LOCAL HISTORIC DISTRICT: Dilworth

PROPERTY ADDRESS: 1936 Park Road

SUMMARY OF REQUEST: Addition

HDCRMI 2019-00599

A2

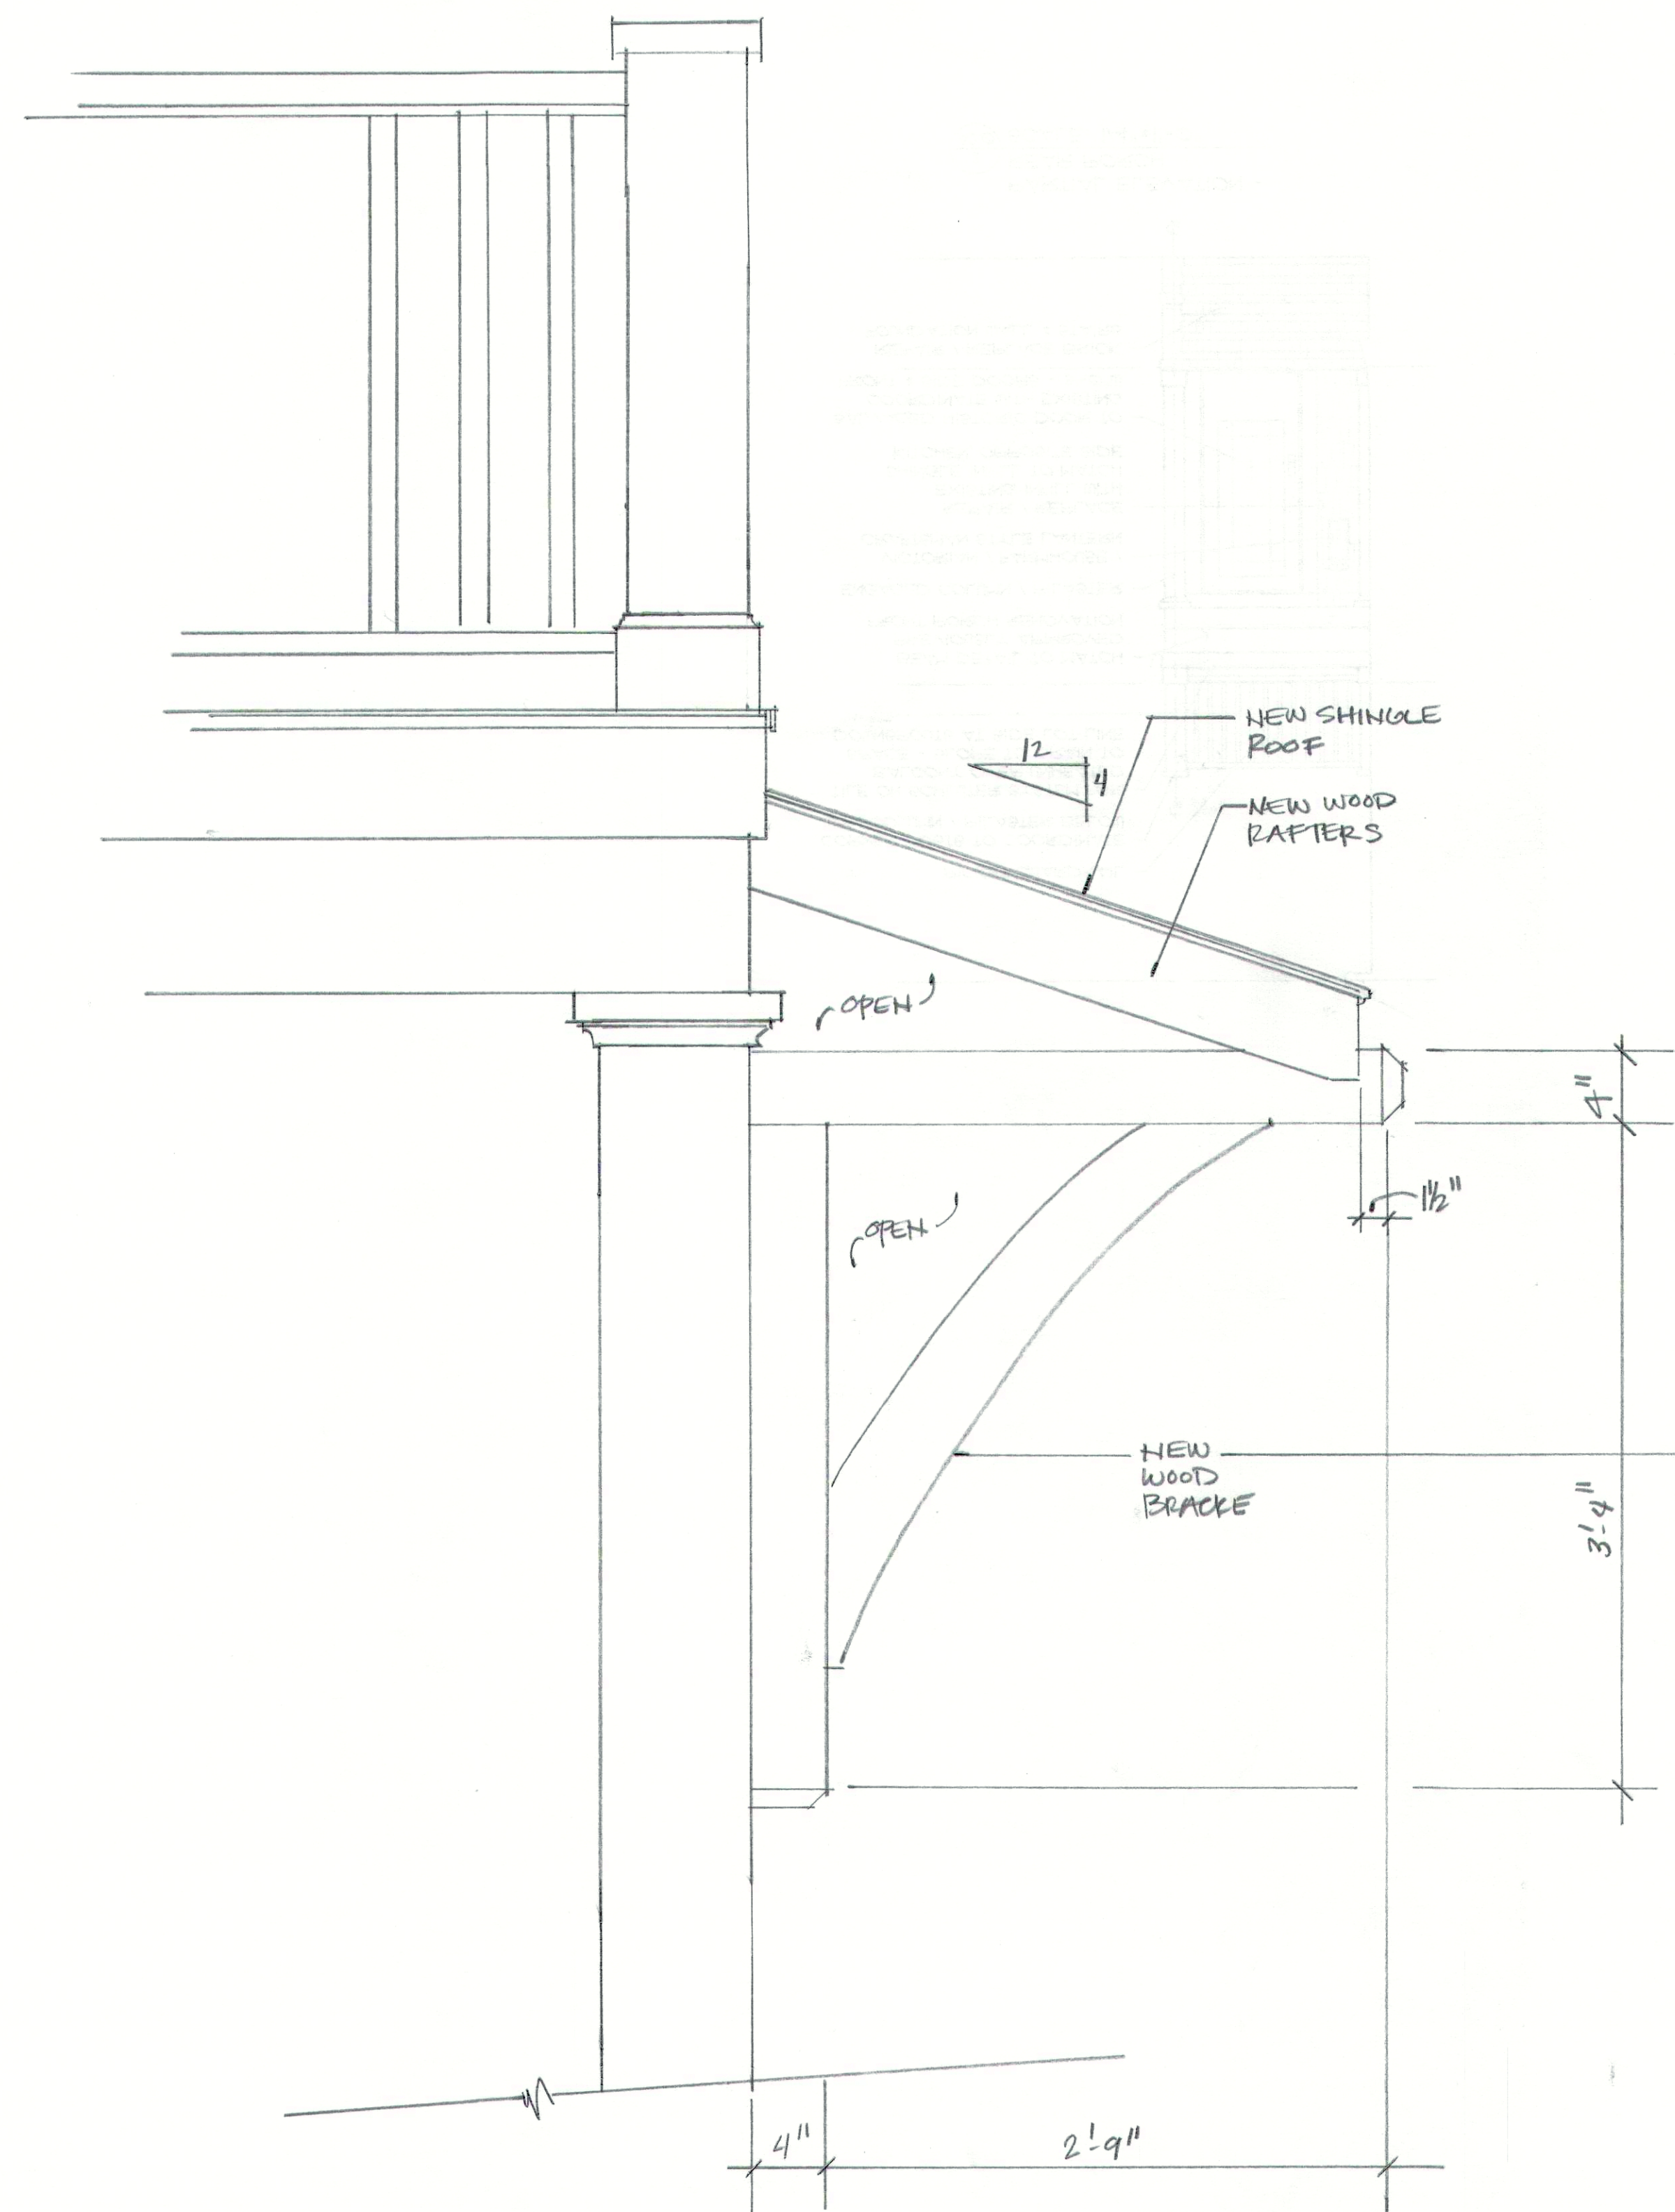
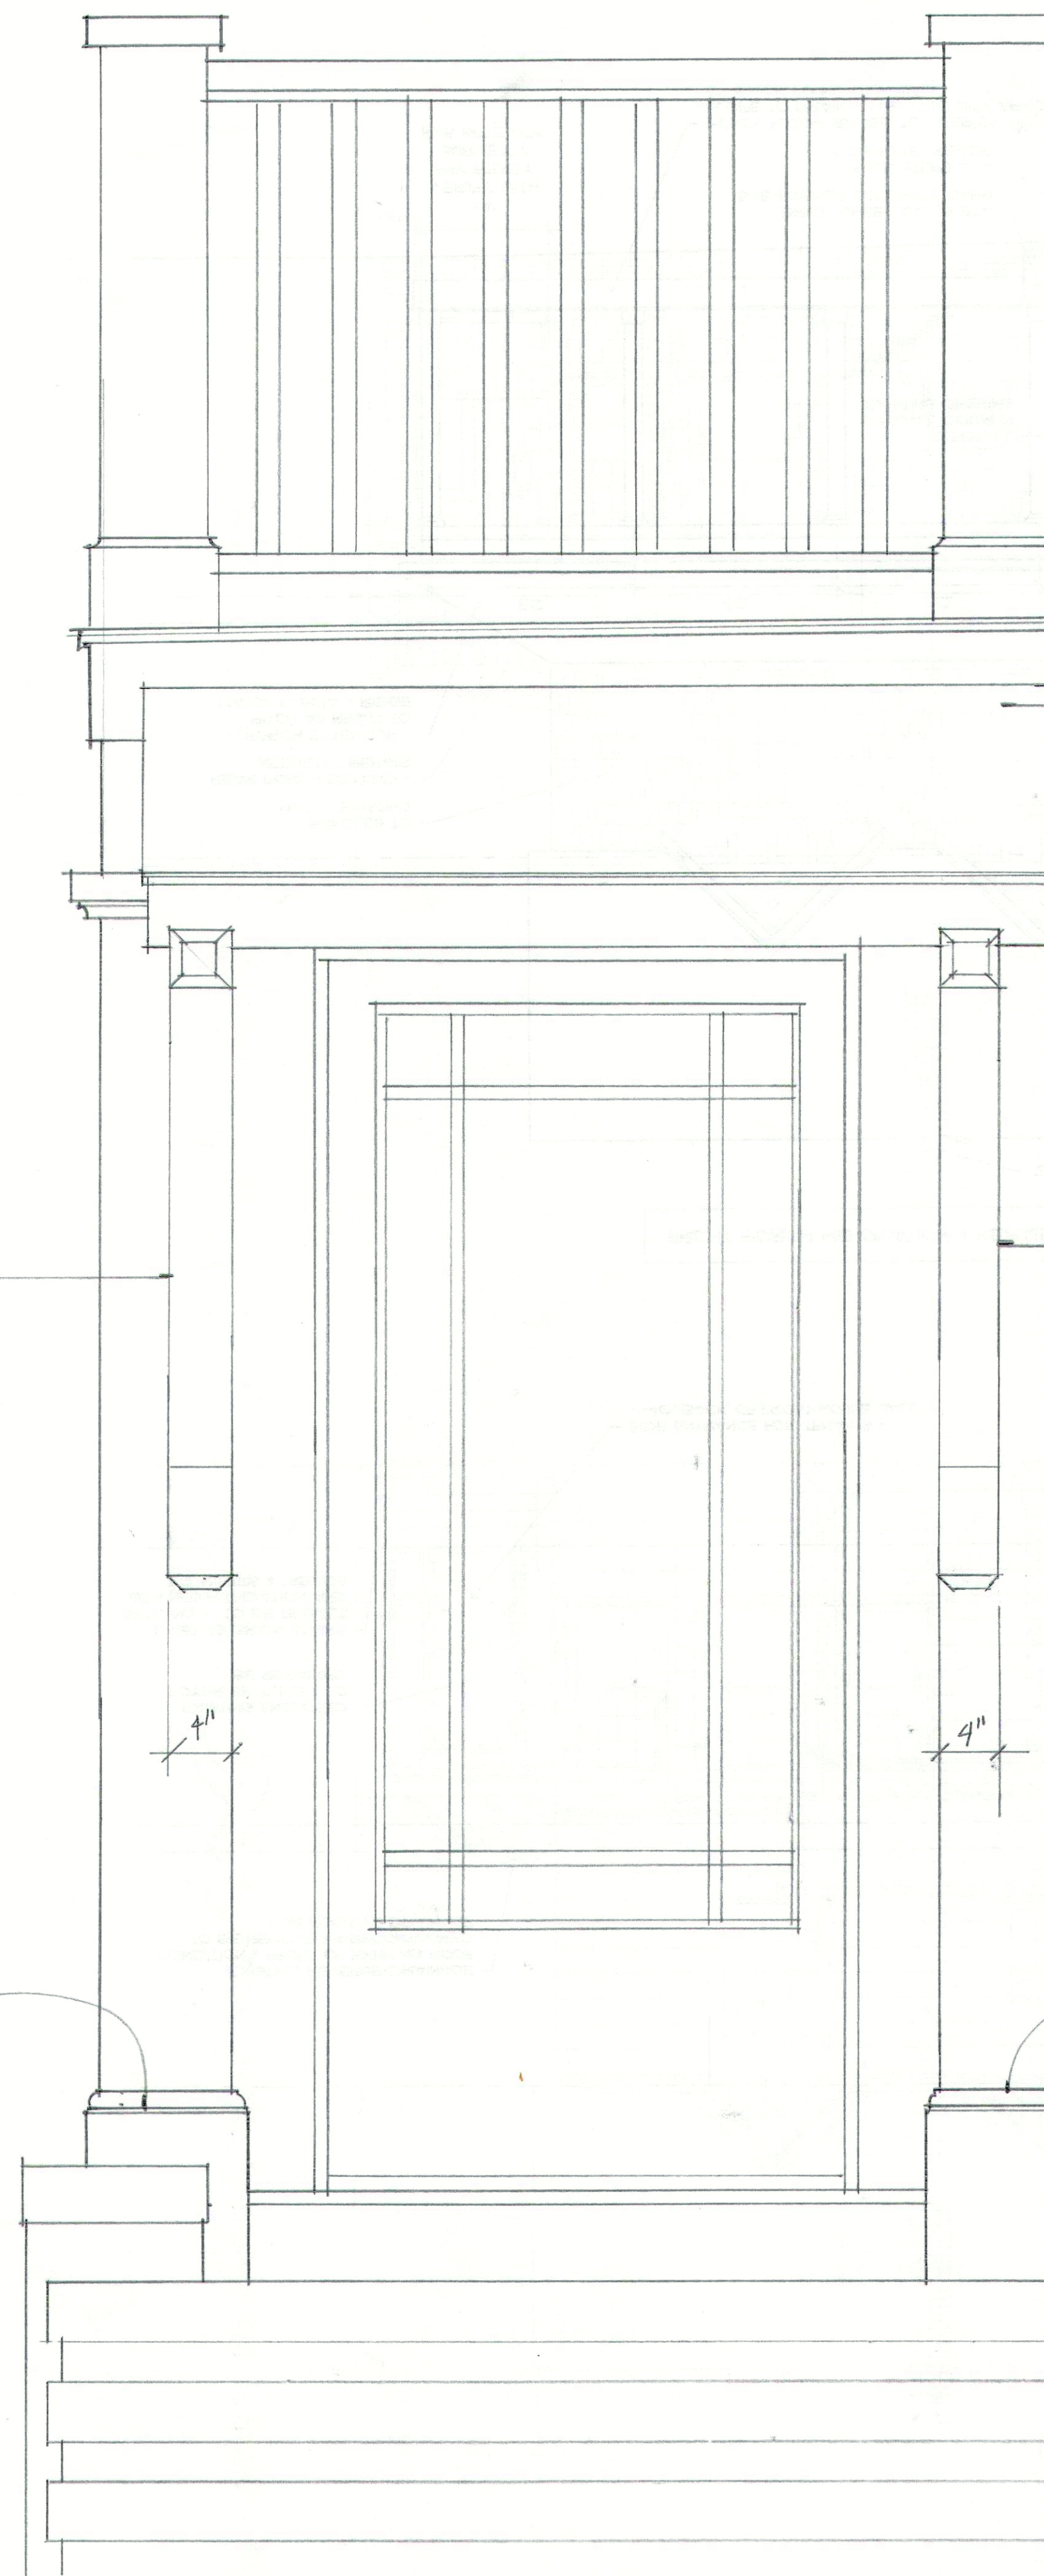
1. The proposed bracket design is incongruous with the Victorian elements on the building. A bracket/corbel that is a simple nod to Victorian-style would fit better than the proposed Craftsman-style bracket, as outlined in Porches, page 6.14 #3.
2. The proposal for the shed roof addition is not incongruous with the District and meets the guidelines for Additions 7.2.
3. Minor revisions may be reviewed by staff.
